Road & Bridge Design Publications

Monthly Update – March 2015

Revisions for the month of **March** are listed and displayed below. New special details will be included in projects submitted for the **June** letting as is stated on the special detail index sheets. E-mail questions related to the road changes to MDOT-Road-Design-Standards@michigan.gov. E-mail Bridge related questions to MDOT-Bridge-Design-Standards@michigan.gov.

DRAINAGE STRUCTURES

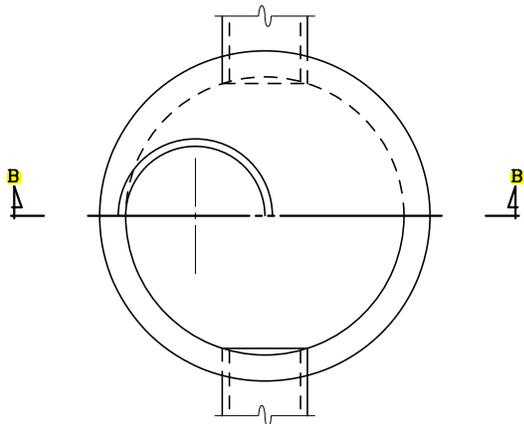
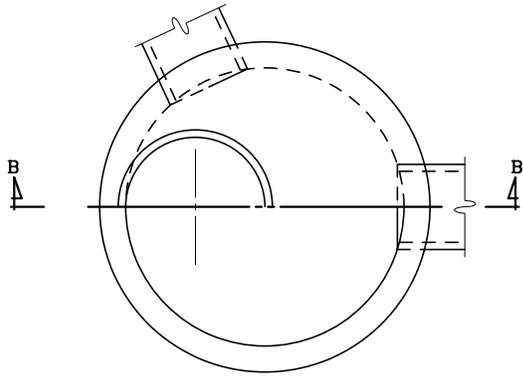
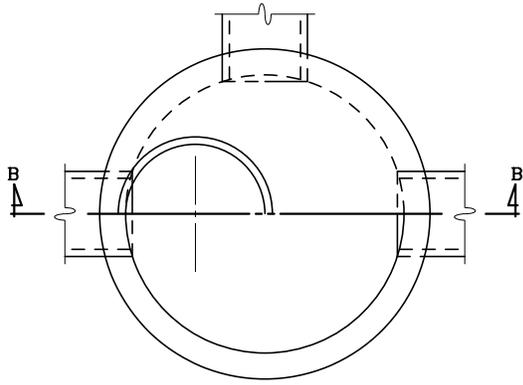
R-1-G: Drainage Structures: Added details for larger diameter drainage structures (84”, 96”, 108”, & 120” diameters) on sheets 5-8. Standard pay items have been added for these structures.

8.21.01

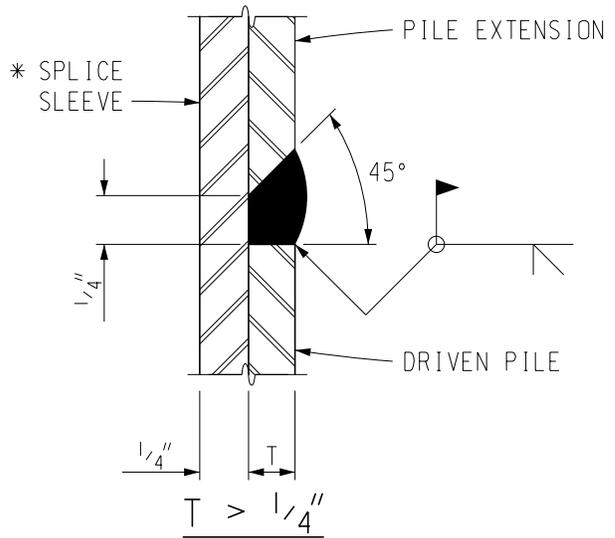
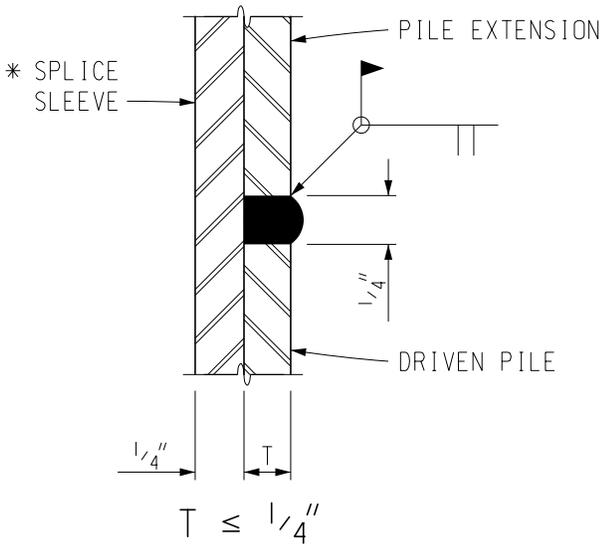
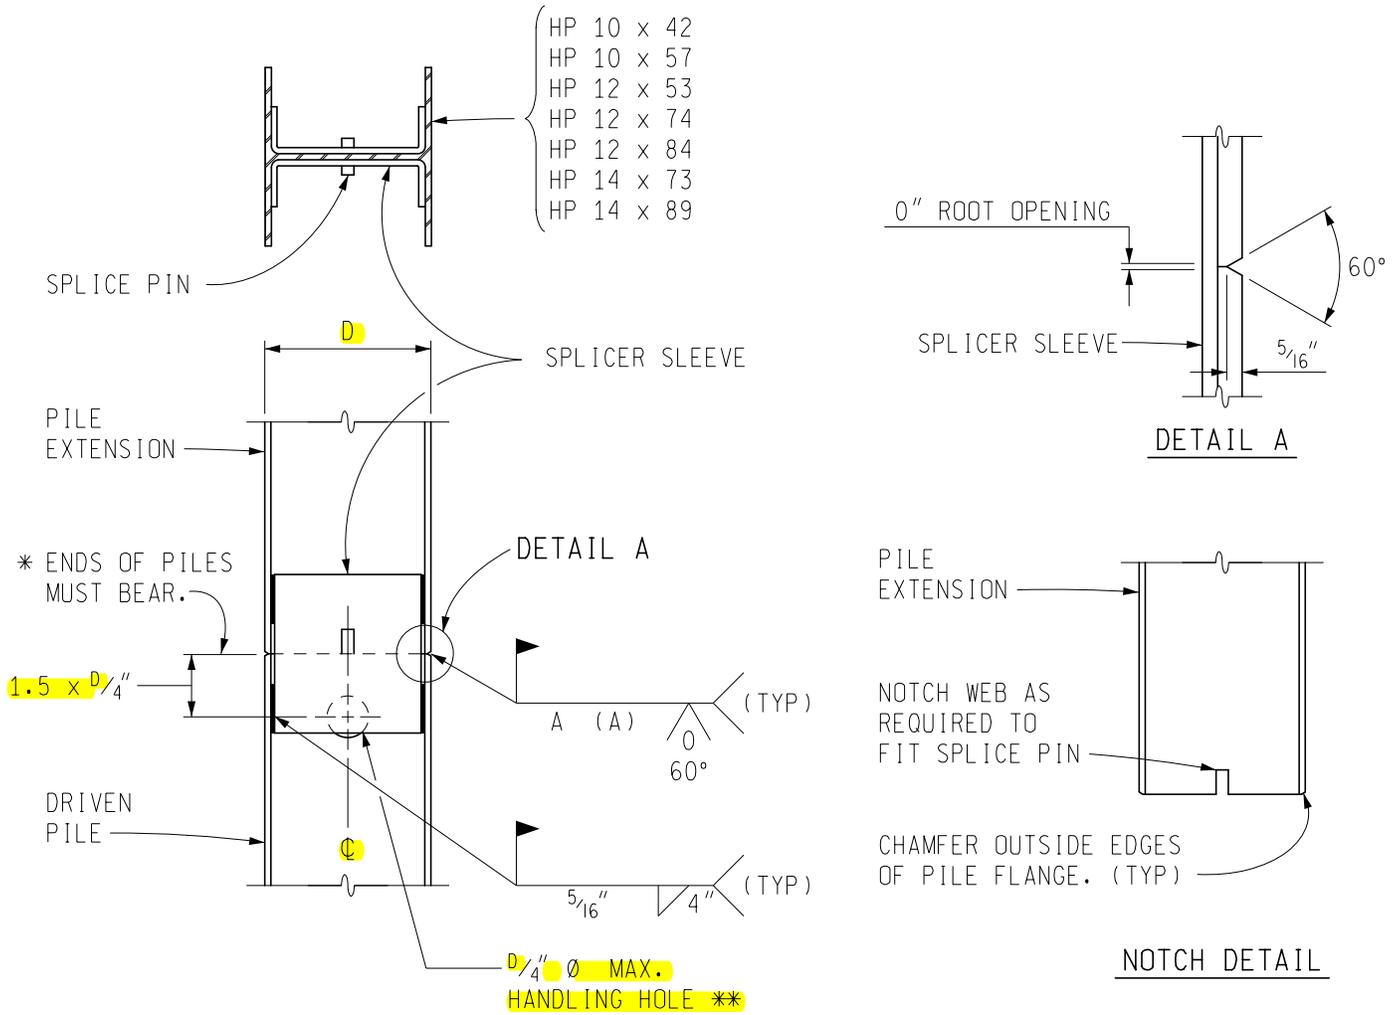
8.21.01, 8.21.02 & 8.21.02 A: Added handling holes and use criteria.

** $D/4$ Ø MAX. HANDLING HOLES
 2 HOLES MAX., 180° APART
